Contractor: **Kubricky Construction**
 Job Name: **Middlebury EWP3(1)**
 Location: **Middlebury, Vt.**
 Job # **169-17** Date: **5/18/2017**
 Drawn By: **JH**

Product I.D. DI 22+56.8 Diameter: **48"**
 Invert: **No** Ladders: **No** Coating: **No** Access Size: **24" x 24"**
 Cast Iron / Hatch: **Neenah R-3589 24" x 24" x 8" Frame and Type Grate (3-flange)**

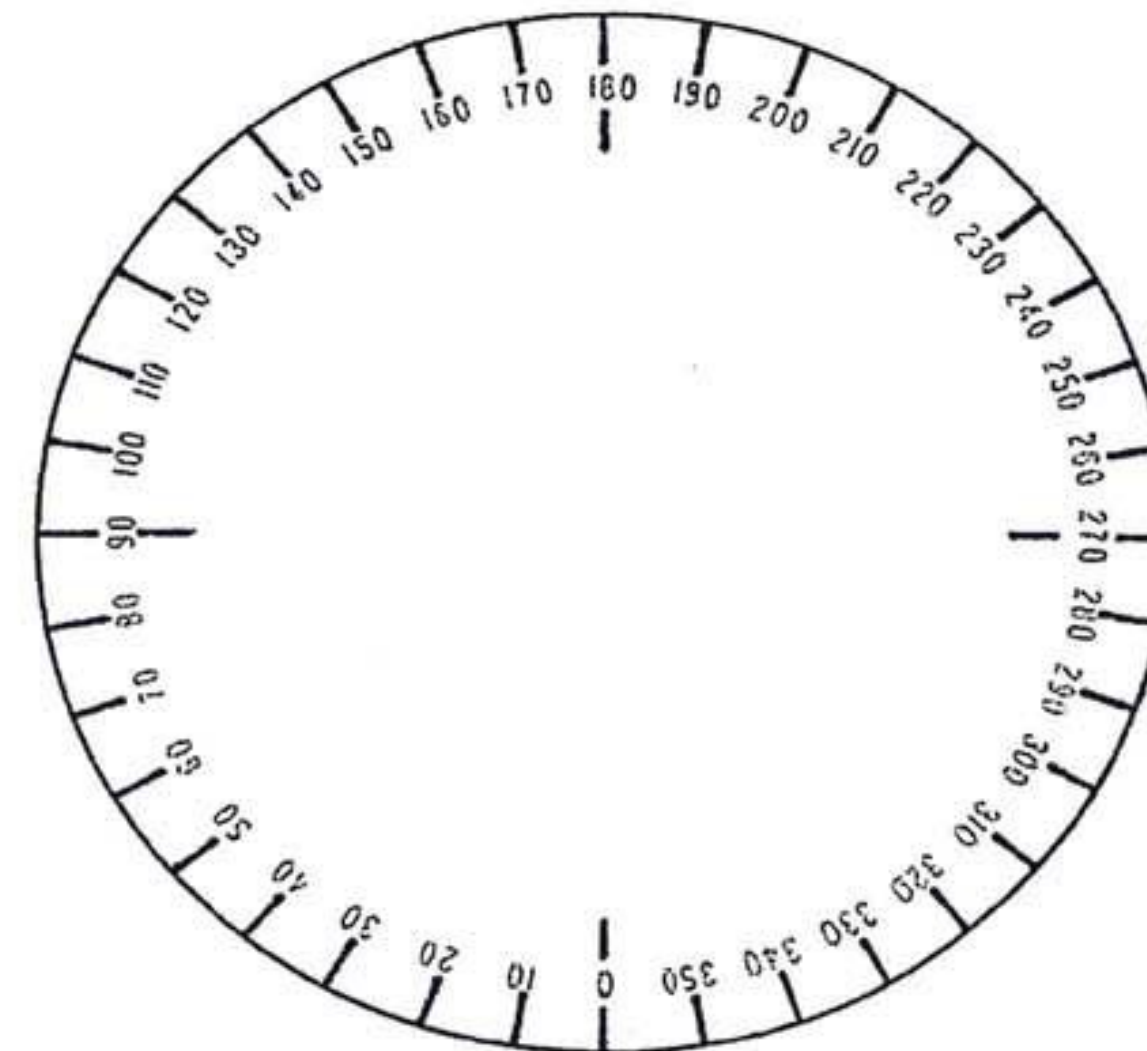
Typically VTrans calls for 18" mins sump, but this is ok for the temporary structure.

Should be Neenah Type "H" grate. (Catalog No. R-3589-A)
